ADDENDUM NO. 2
TO RFP #2024-04
KEYS ROAD RESERVOIR PROJECT
DATE ISSUED: June 28, 2024

SUBJECT: CLARIFICATIONS AND CHANGES TO THE PLANS AND SPECIFICATIONS

DWG NO.: M02

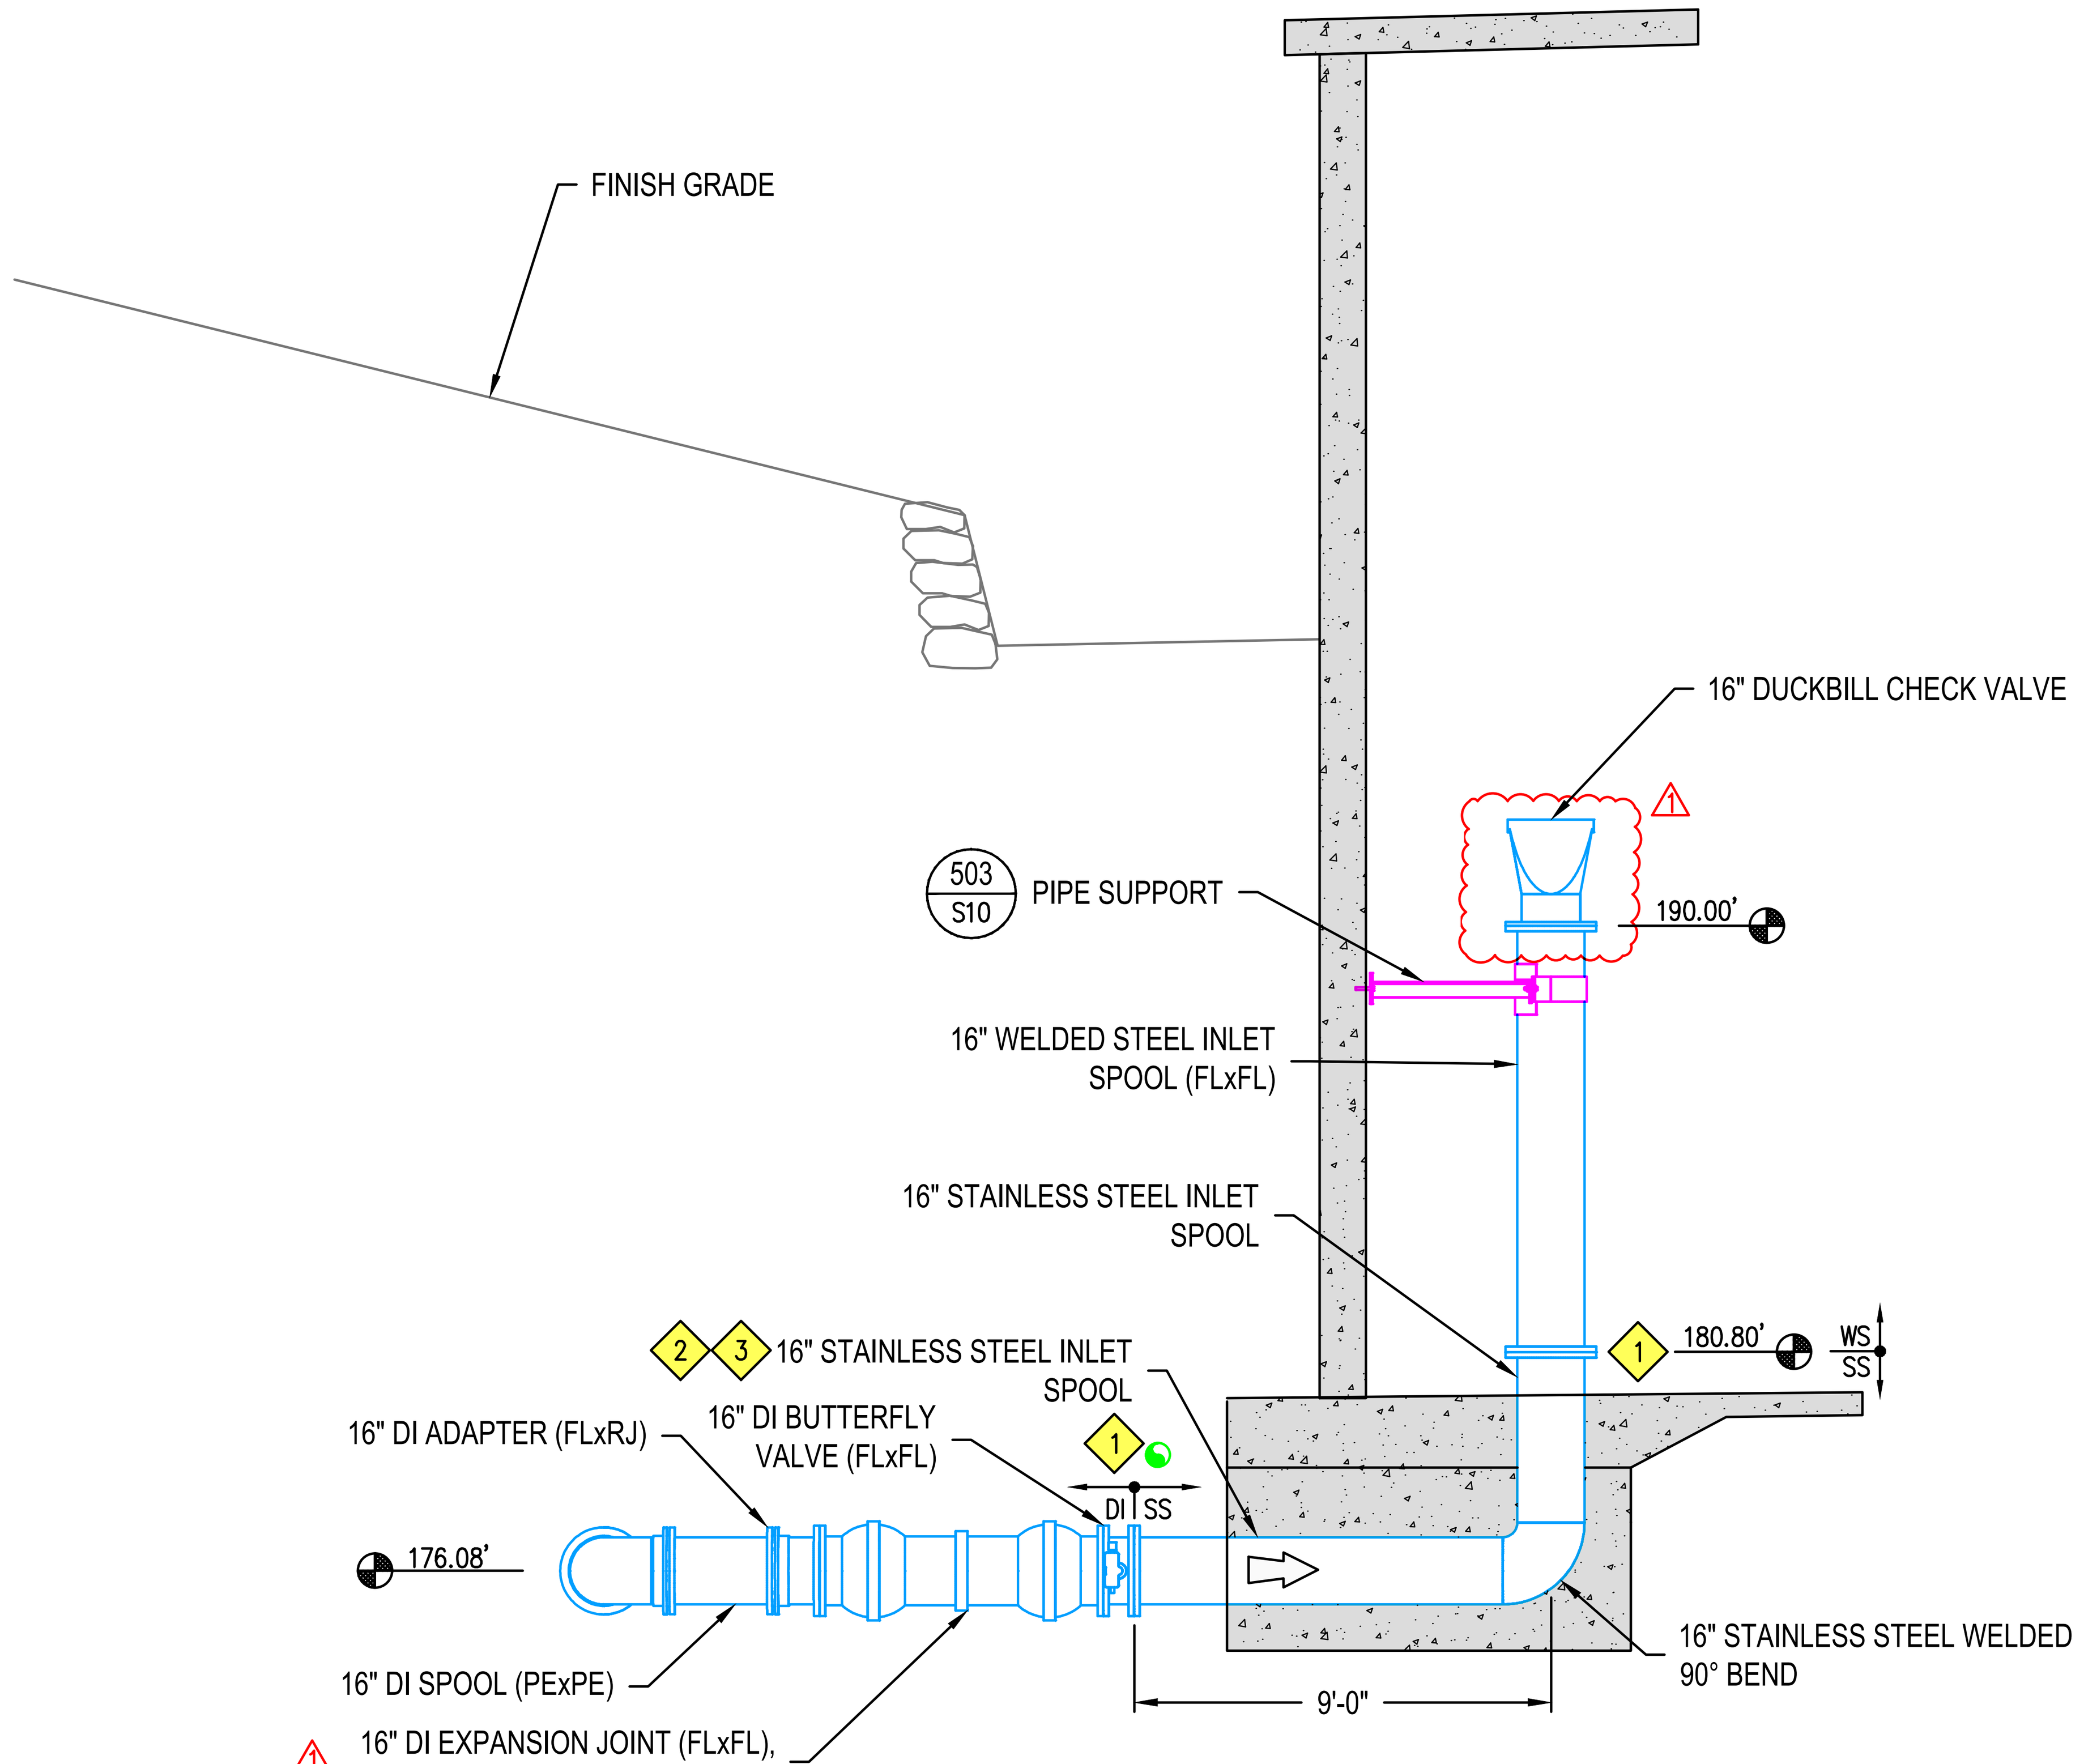
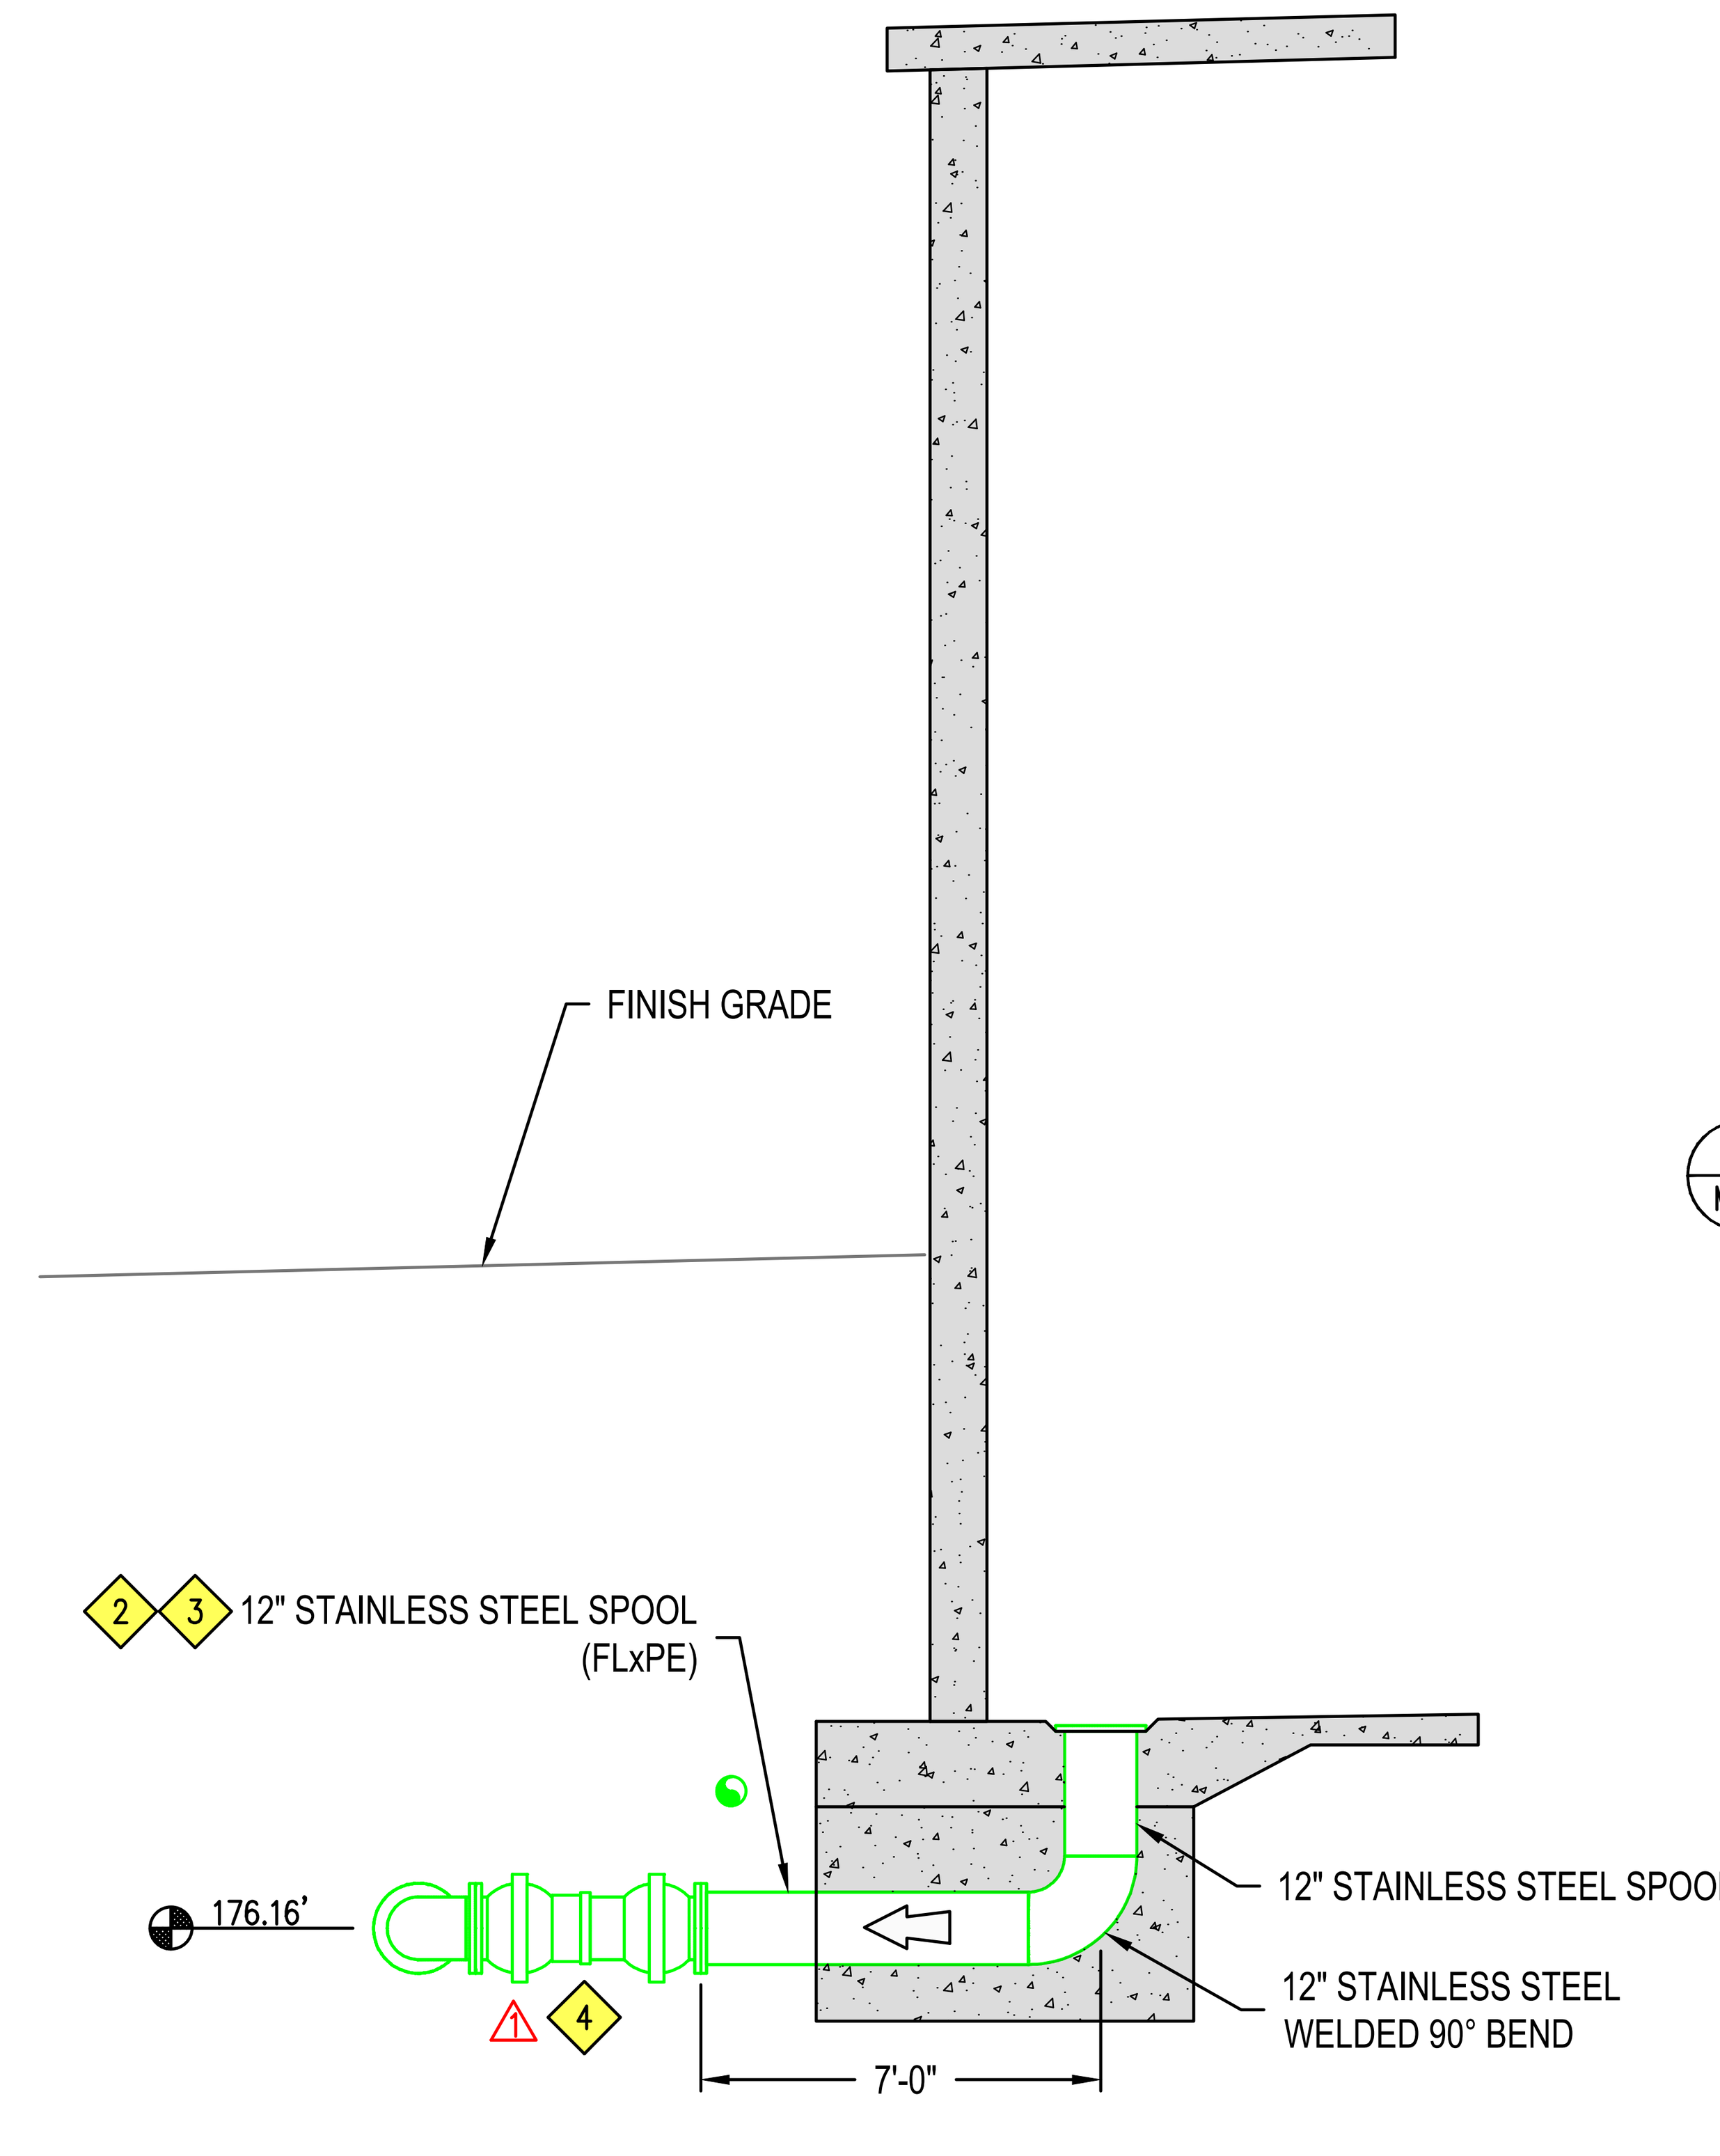
i. **Question**: Spec section 15.40.02 covers the double ball expansion joints, but does not specify the expansion required. 16" Flex-Tends are available with 8", 16", or 24" of expansion while 12" Flex-Tends are available with 4", 8", or 12" of expansion. Please clarify what is required here.

y. **Question**: Drawing M02 shows the pipe penetrations to the reservoir and both the 16” and 12” stainless steel embedded piping are shown with an oddball radius on the 90 elbows. Standard radius 90 elbows in steel and stainless steel are 1.5 X the pipe diameter.

z. **Question**: Drawing M02 in key note 3 requires tape wrap on exposed stainless steel pipe and flanges. Could you provide more information? The areas indicated for wrapping appear to be just the buried portion not embedded in concrete – is that correct? Is any primer required for the tape? Is there a minimum overlap? And can you provide a manufacturer and model of tape?

Answer: Refer to re-issued Dwg M02 in this addendum for updated information.

Answer: Graphical display of bends on steel piping are not dimensioned on the drawings and are only for representation purposes. Bend radii and other dimensions shall be provided according to the specified standards.

Answer: The tape wrapping referenced on Dwg M02 is required only on the exposed (buried) portion of the indicated piping. Refer reissued Dwg M02 as part of this addendum for tape wrap information.

1. DIELECTRIC ISOLATION KIT AT FLANGE CONNECTION. (305 M04)
2. STAINLESS STEEL PIPE TO BE DIELECTRICALLY ISOLATED FROM CONCRETE REBAR IN RESERVOIR FOOTING. PIPE SUPPORTS MUST BE NONCONDUCTIVE OR DIELECTRICALLY ISOLATED.
3. TAPE WRAP EXPOSED STAINLESS STEEL PIPE AND FLANGES WITH 20 MIL PVC PIPE TAPE. TAPE WRAP SHALL BE A 20 MIL MINIMUM PVC TAPE THAT IS IAPMO/UPC LISTED, CHRISTY'S PIPE WRAP OR EQUAL. APPLY AT 50% OVERLAP, 40 MIL TOTAL.
4. 12" DI EXPANSION JOINT (FLxFL), W/ 4" EXPANSION CAPACITY.
